SERVICE CHANGES

1. Change on Skirts Set Etc.

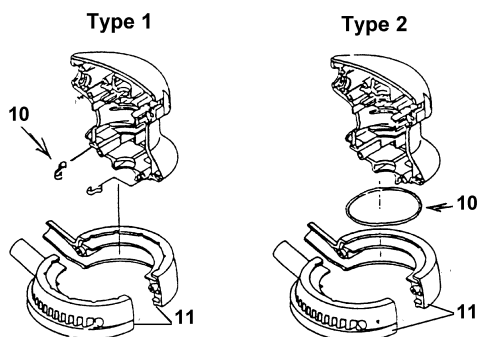
Item No.	Description	Type 1	Type 2
10	Leaf Spring / O Ring 75	232166-0 - Leaf Spring (2pcs)	213755-0 - O Ring 75 (1pc)
11	Skirt Set	182922-7	183088-6

Above parts are completely interchangeable as a set.
Type 2 Sander becomes No Positive Stop function.

2. Change on Ball Bearing.

Item No.	Description	Type 1	Type 2
20	Ball Bearing 6002DDW	211227-9	211236-8

Above parts are completely interchangeable.

To Prevent excess rotation when the Sander is NO LOAD, please change to Type 2 Ball Bearing which is packed with a thinner grease. There is no visual difference between Type 1 & Type 2 Ball Bearings.
